SYSTEM BLOCK DIAGRAM

PROJECT : QU1

44. 12/21 P19---del R443,ADD R446(HW LOSE)
45. 12/26 P16---change Y2 P/N to meet ACL.(BG625000737)
46. 12/21 P17---ADD R122 for HW lose
47. 12/23 P19---Add R324 for LCD white screen issue
48. 12/27 P19---Change F8=7A fuse (P/N:DK700WFW006)(LCD INRUSH CURRENT=3A)
49. 12/23 P26---del R587(LAN link issue)
50. 12/29 P26---change CN11 (P/N:DFTJ12FS001)(Change LED color)
51. 12/26 P31---change CN5,CN8 P/N to meet ACL.(DFHD52MS057)
52. 12/29 P12---ADD R689 to link VCC3(Therm_Alert# must push Hi)

NB Thermal Sensor

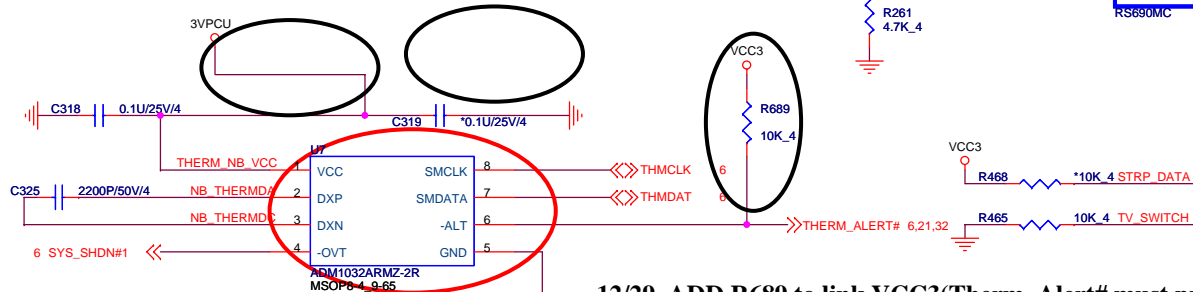
12/29 ADD R689 to link VCC3(Therm_Alert# must push Hi)

Size	Document Number	Rev
	RS690MC PLL & VEDIO I/F	A
Date:	Saturday, February 21, 2009	Sheet 12 of 44

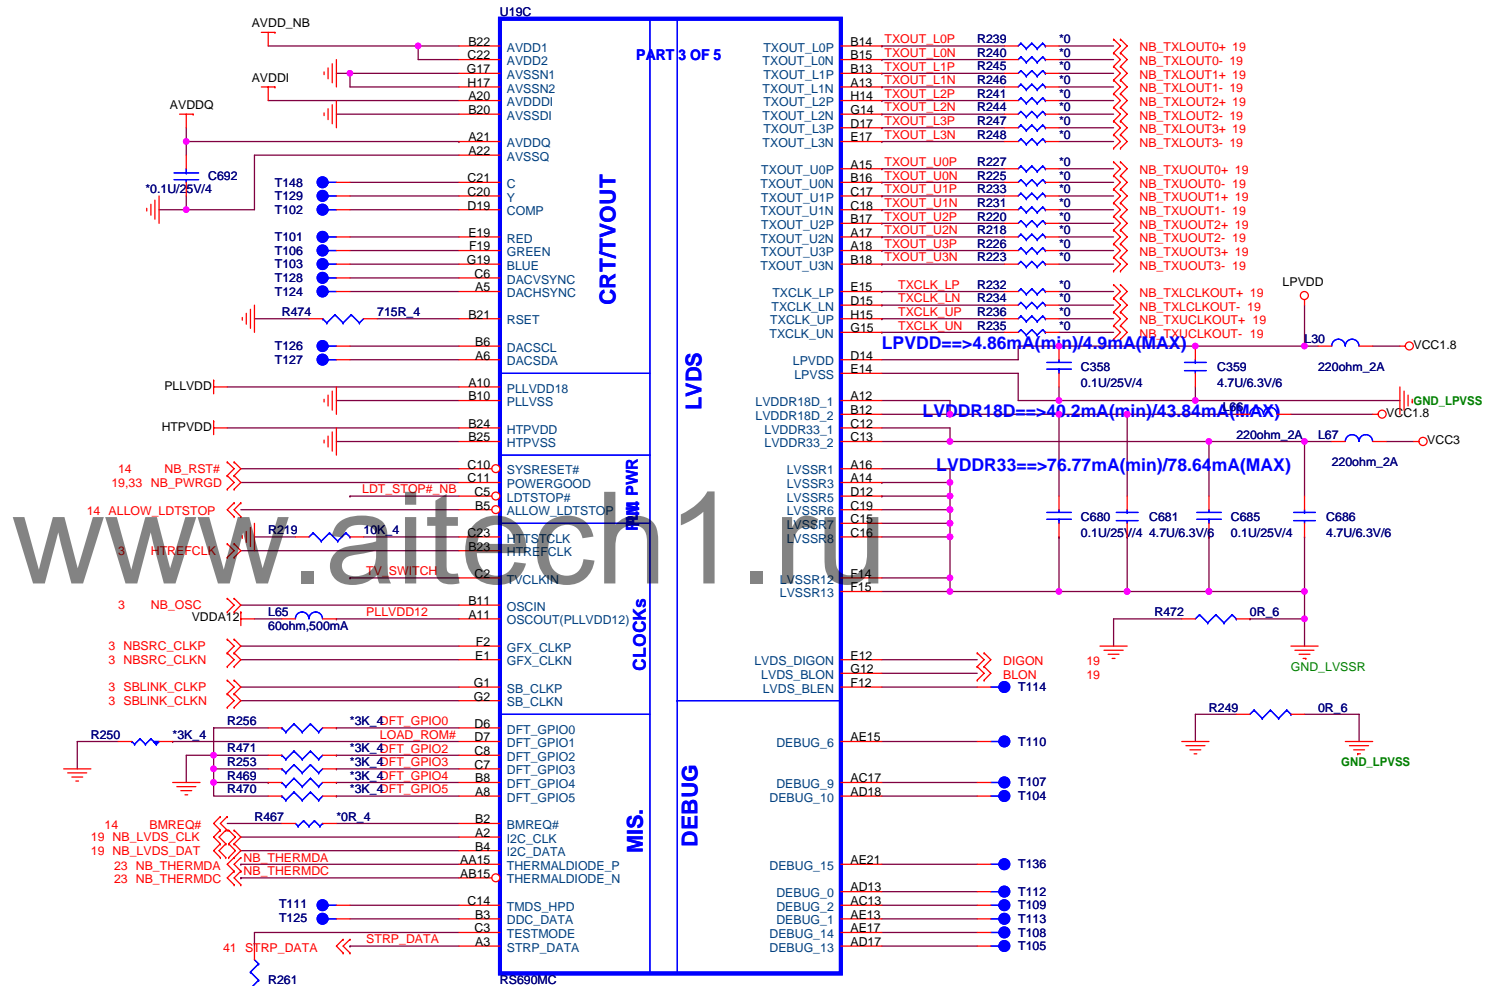
12/02 change U7 P/N:AL001032002

USB PWR

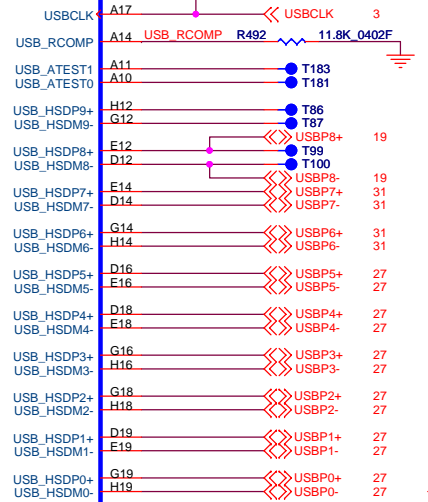
12/21 ADD R122 for HW Lose

TO INVERTER POWER

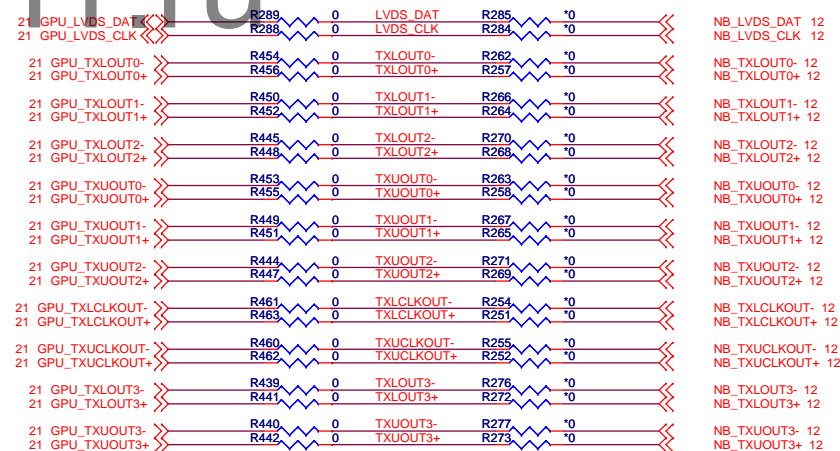
Change F8=7A fuse (P/N:DK700WFU006)(LCD INRUSH CURRENT=3A)

LAN Power

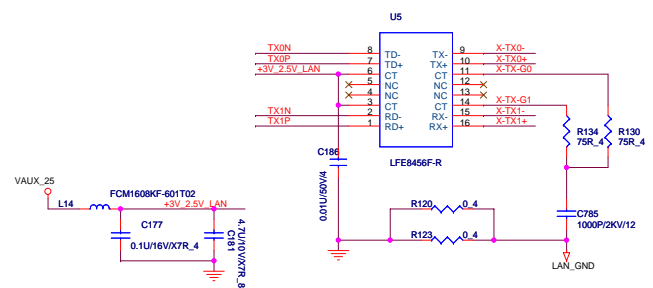
12/23 del R587(LAN link issue)

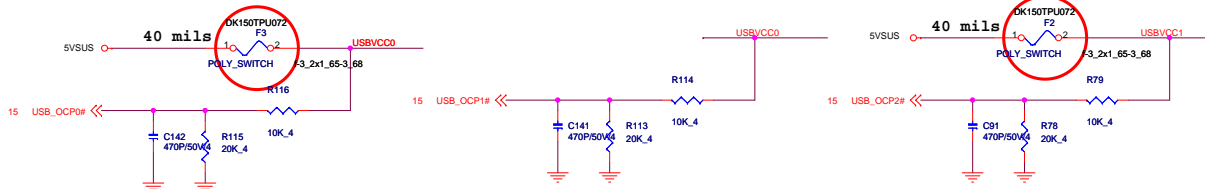
12/05 Layout update the CN11 Footprint
12/29 R226---change CN11 (P/N:DFTJ12FS001)(Change LED color)

For S-ATA HDD POWER

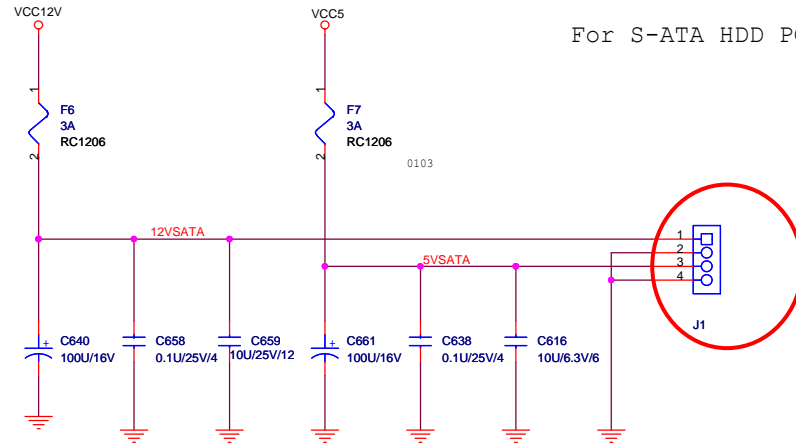
12/02 change J1,J2 PN:DFHS04FR207

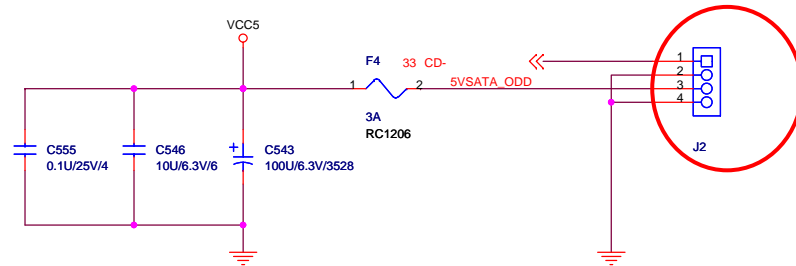
12/05 change CN6,CN7 Footprint sata-aba-sat-010-k07-7p-r

Mini Card (WLAN)

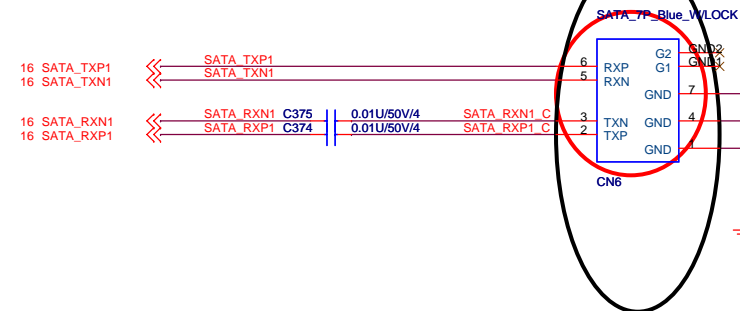
12/26 change CN5,CN8 P/N to meet ACL.(DFHD52MS057)

Mini Card (TV Card)

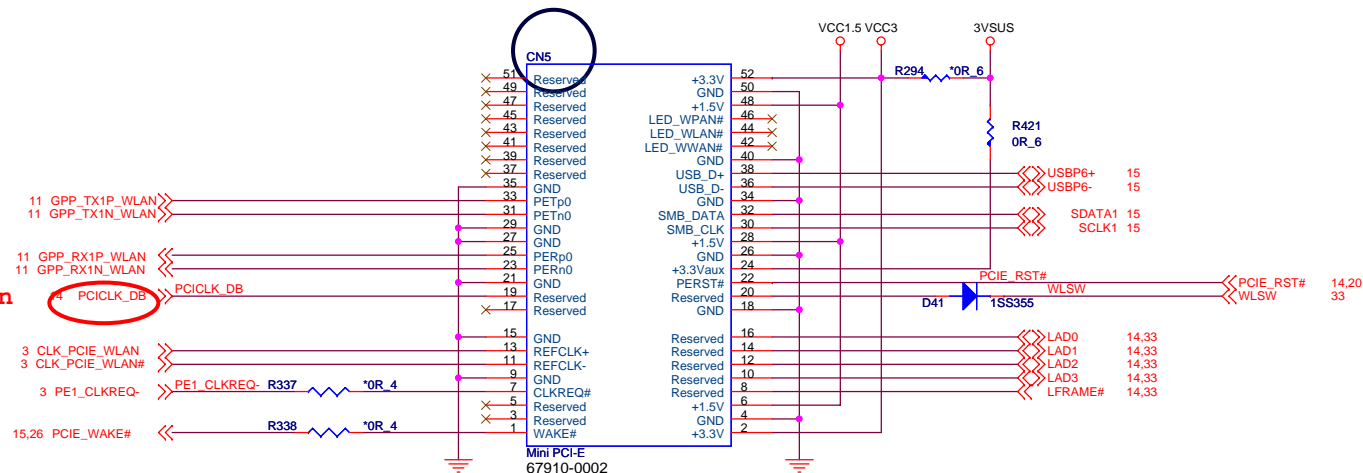
12/04 ADD debug port function

12/26 change CN5,CN8 P/N to meet ACL.(DFHD52MS057)

FAN CONN

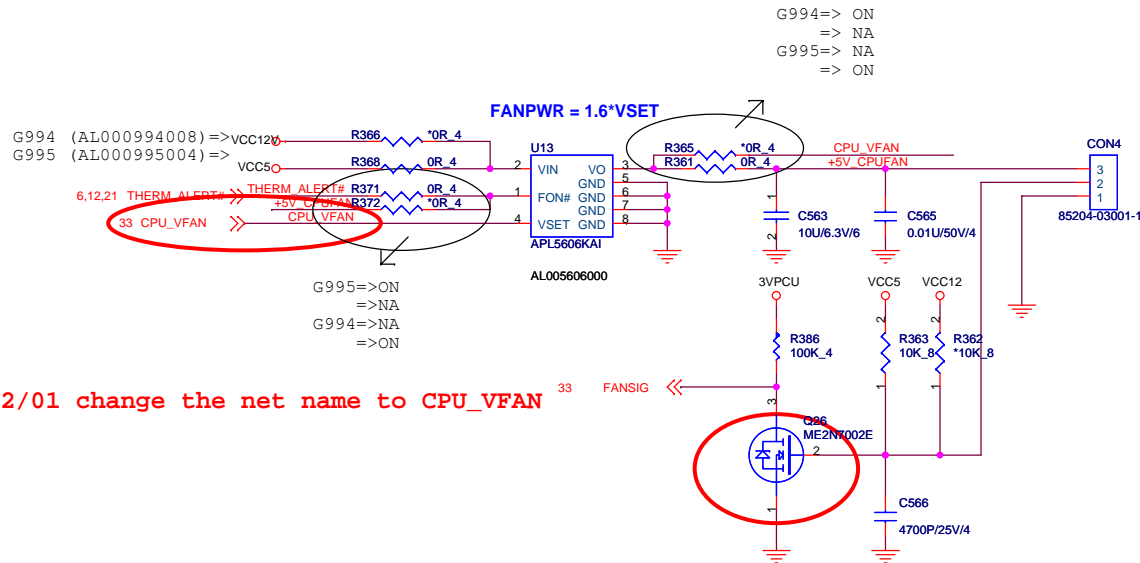
12/01 change the net name to CPU_VFAN

12/01 change the footprint to SOT23_213-3_3-2

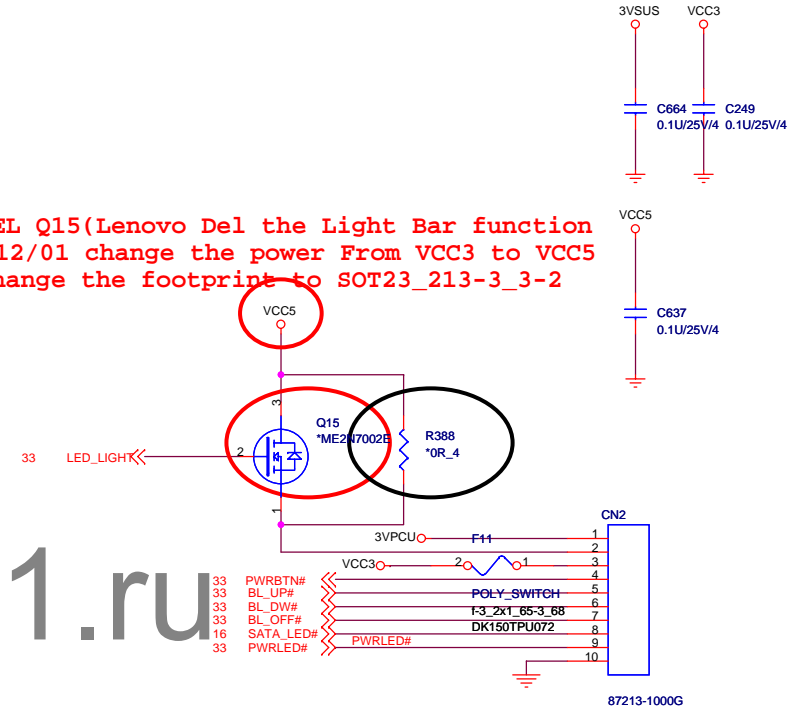
12/01 DEL Q15(Lenovo Del the Light Bar function
12/01 change the power From VCC3 to VCC5
12/01 change the footprint to SOT23_213-3_3-2

12/01 change the net name to VFAN2

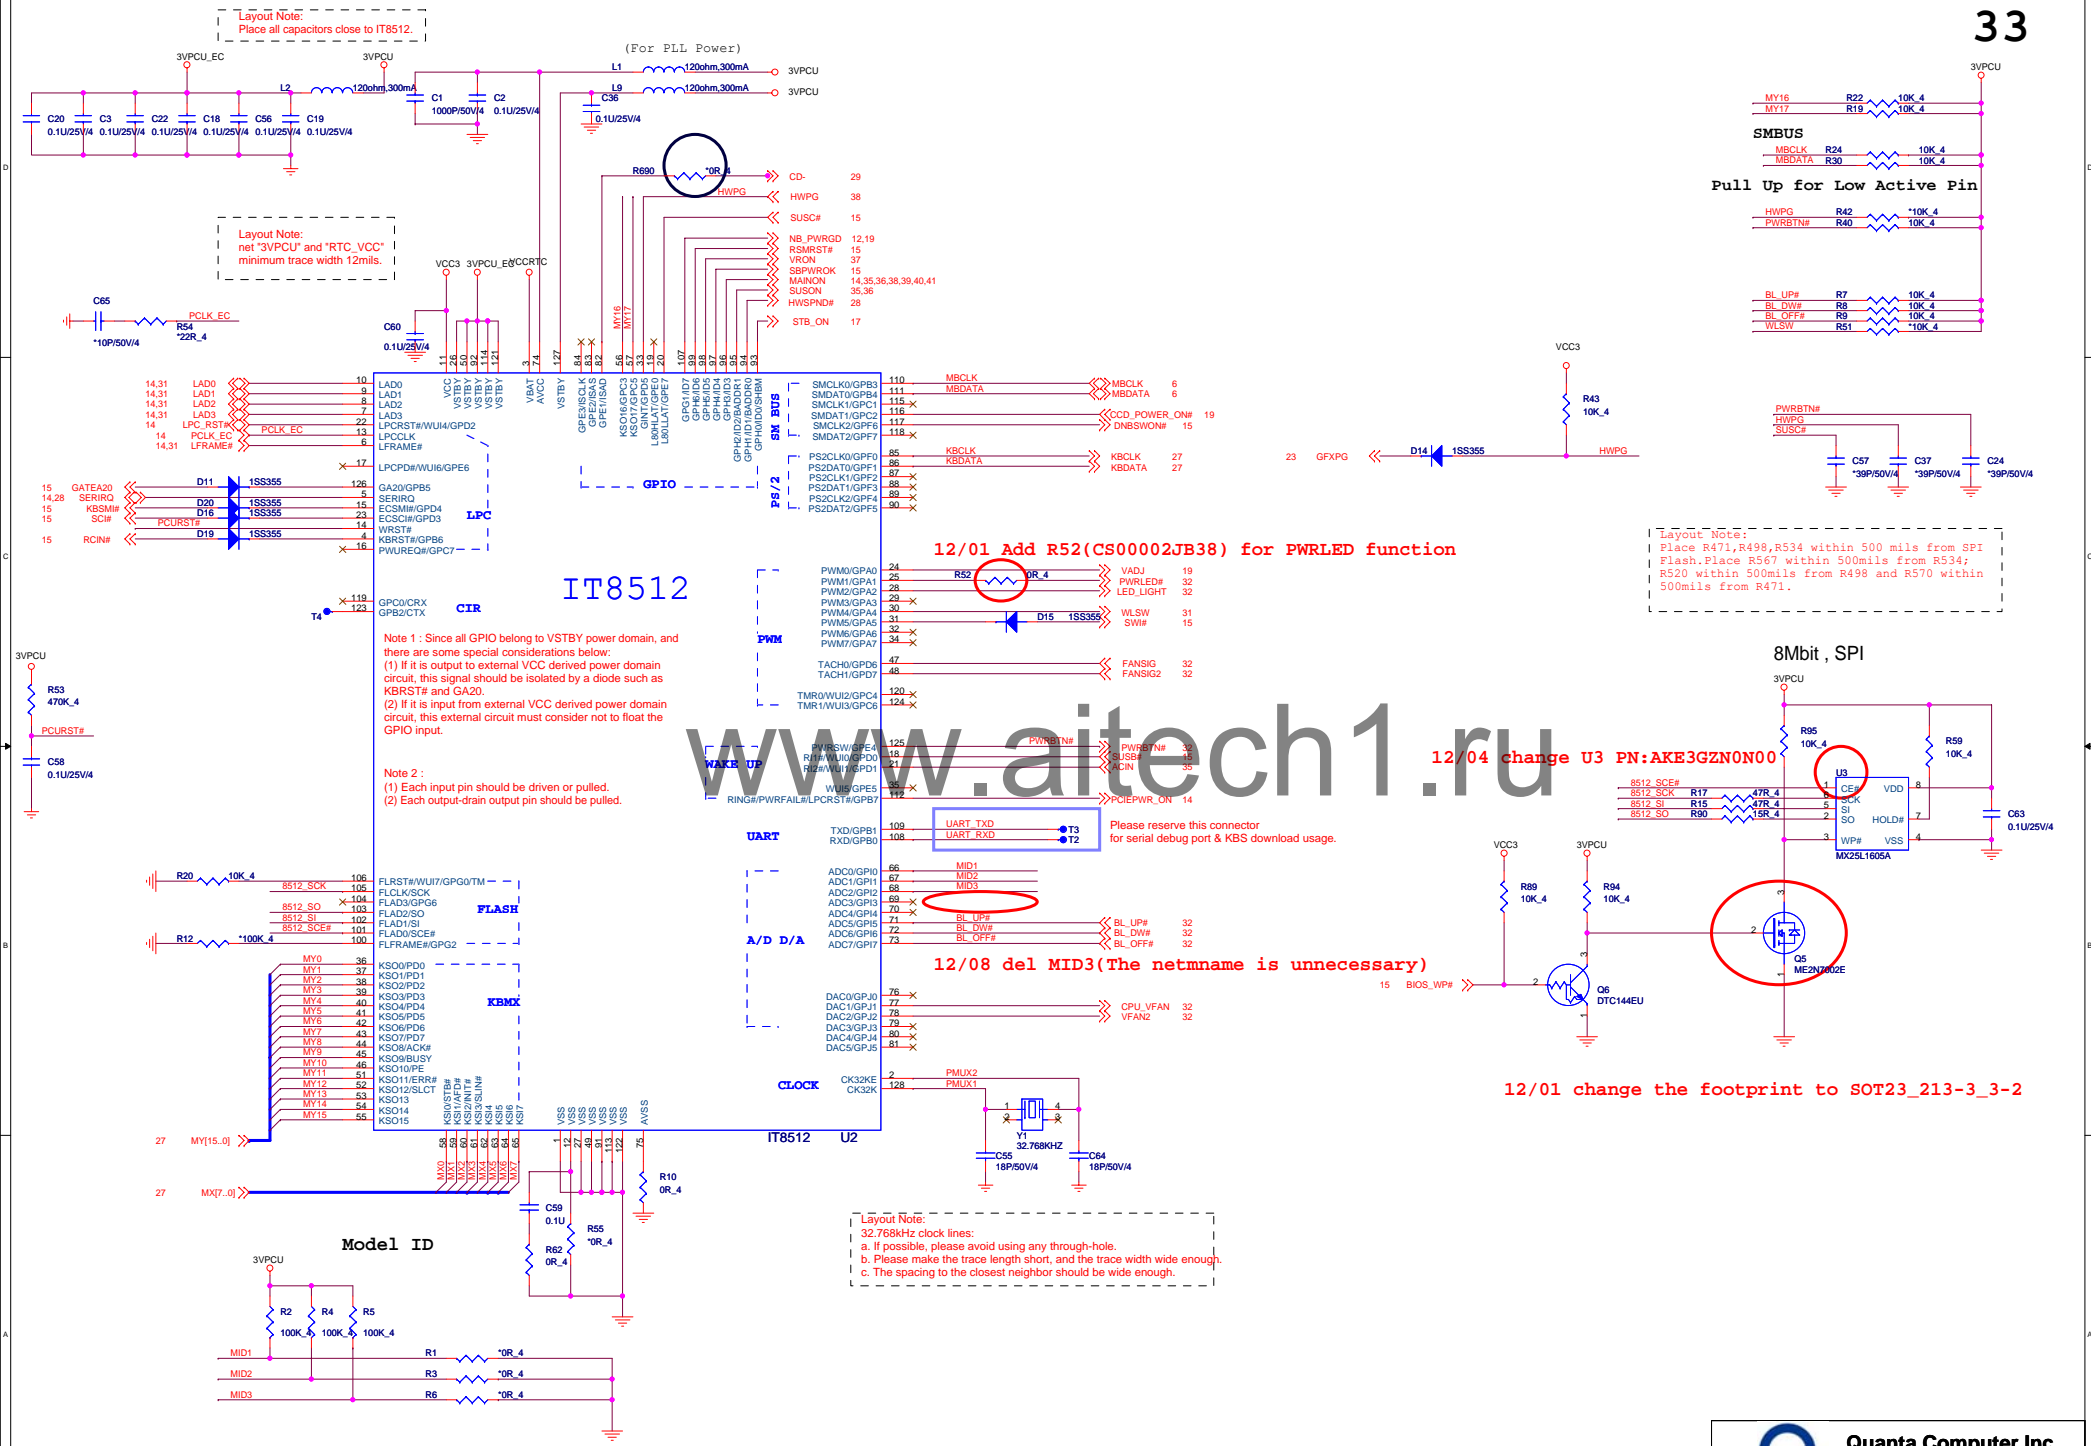
12/01 change the footprint to SOT23_213-3_3-2

12/01 del U1,Q1,Q3,R13,C11,R21,R11,R29
